TITLE	DWG. NO.	REV.	APV
2020 MOUNTAIN AIRE	VI5000171	E	FTBM
3-PHASE ROCKER / RECLINER	DATE	12.10.18	12.12.18
W/ HOOP BASE	F.PANCAK

REVISIONS

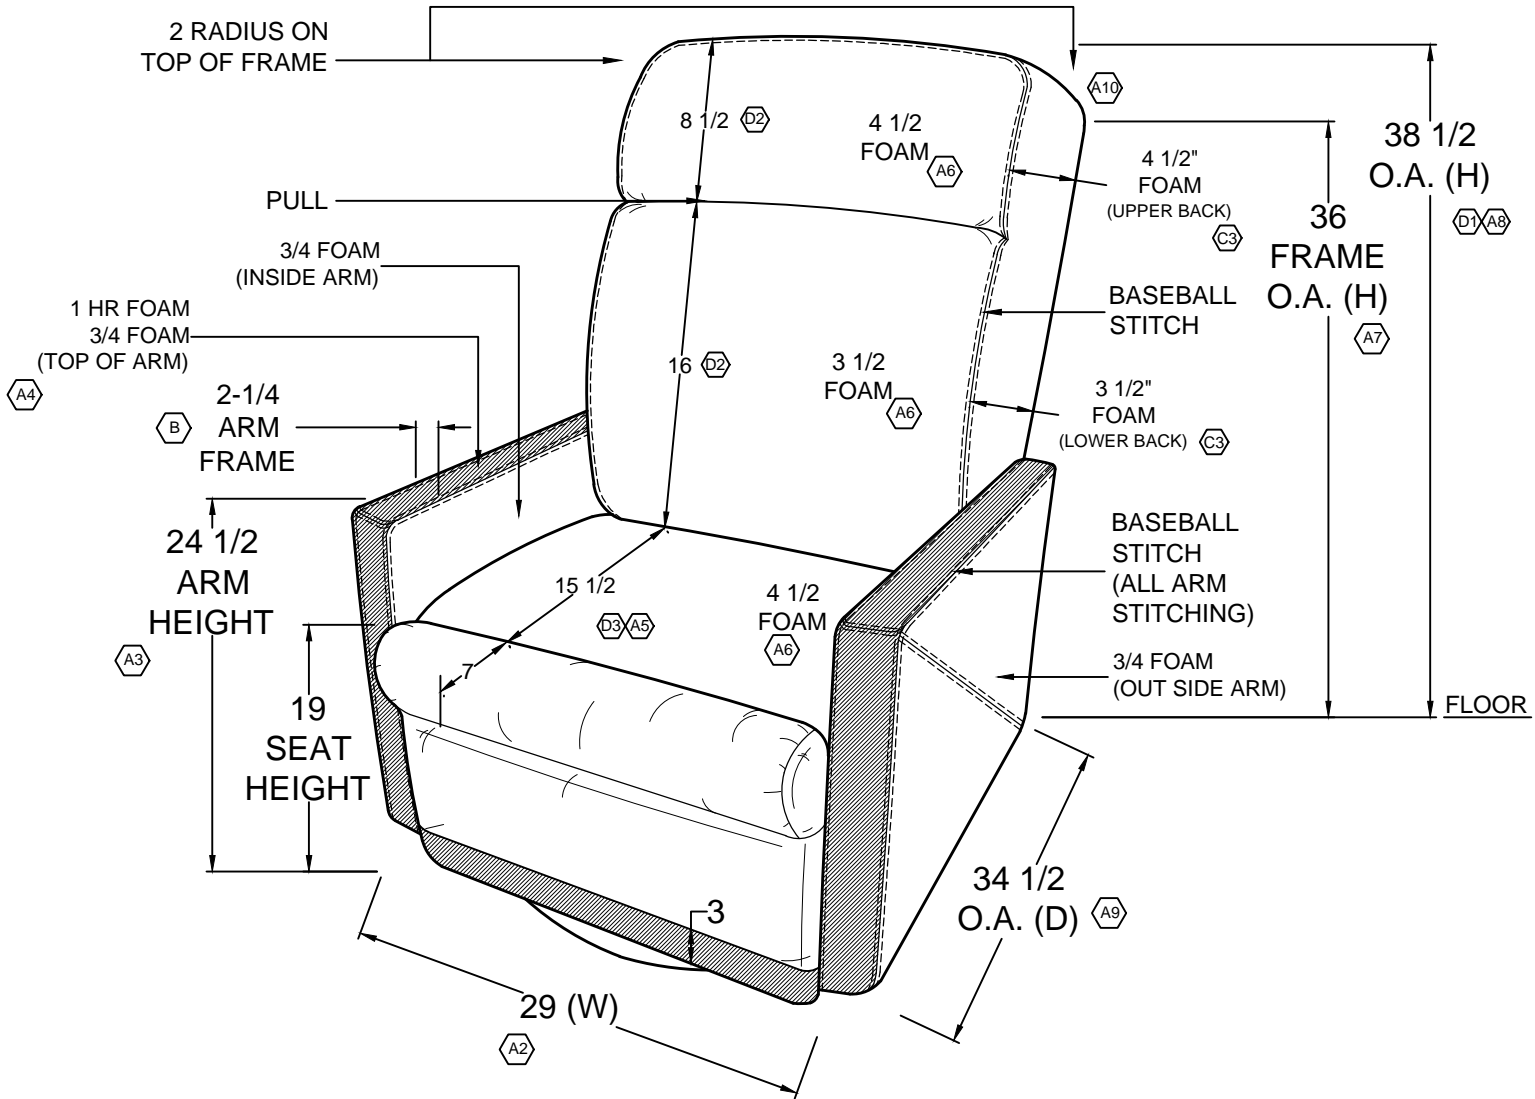
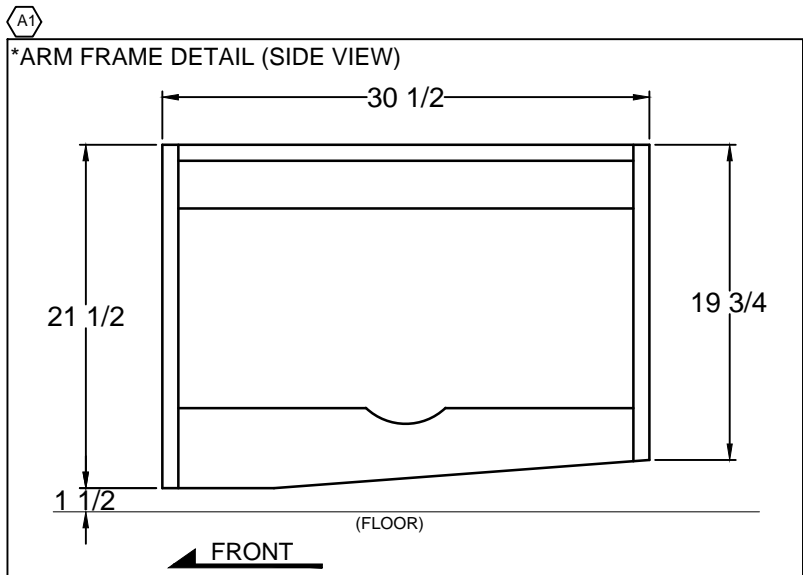
- *NOTE:**
- CONNECT SEAT WRAP TO FOOTREST PANEL.
 - ADD BLACK DECKING SKIRT INSIDE FOOTREST.

JA	E	ADD NOTES TO CONNECT WRAP TO FOOTREST PANEL AND ADD BLACK DECKING SKIRT TO INSIDE FOOTREST. (REF. ECO #010-2020)	02.24.2020
JA	D	PER RB, [1] CHANGE O.A. HEIGHT TO 38-1/2"; WAS 37-1/2"; [2] ADD BACK PILLOW HEIGHT DIMENSIONS; [3] ADD SEAT CUSHION DIMENSIONS (REPLACES SEAT DEPTH DIMENSION); [1] ADD SPRING CLIPS TO SEAT SPRINGS; [2] ADD 8x24 602 SPRINGS x4; [3] ADD 4-1/2" FOAM TO UPPER BACK & 3-1/2" FOAM TO LOWER BACK. (REF. ECO #028-2019); [4] MECHANISM LEG A41081233S 23" WIDE MECH W/SWIVEL 4108-2. (REF. ECO #058-2019)	07.03.19
JA	C	PRODUCTION UPDATE: CHANGE ARM FRAME WIDTH TO 2-1/4"; WAS 2".	06.10.19
JA	B	PRODUCTION UPDATE: CHANGE ARM FRAME WIDTH TO 2-1/4"; WAS 2".	01.28.19
JA	A	PRODUCTION UPDATE: [1] ADD ARM FRAME DETAIL; [2] CHANGE WIDTH TO 29"; WAS 28-1/2"; [3] CHANGE ARM HEIGHT TO 24-1/2"; WAS 27"; [4] ADD FOAM DETAILS TO TOP OF ARM; [5] ADD 20" SEAT DEPTH DIM; [6] ADD BACK AND SEAT CUSHION FOAM DETAILS; [7] CHANGE FRAME HEIGHT TO 36"; WAS 38"; [8] CHANGE O.A. HEIGHT TO 37-1/2"; WAS 40-1/2"; [9] CHANGE DEPTH TO 34-1/2"; WAS 36-1/2"; [10] ADJUSTED BACK OF PILLOW ON ISO DRAWING.	01.23.19
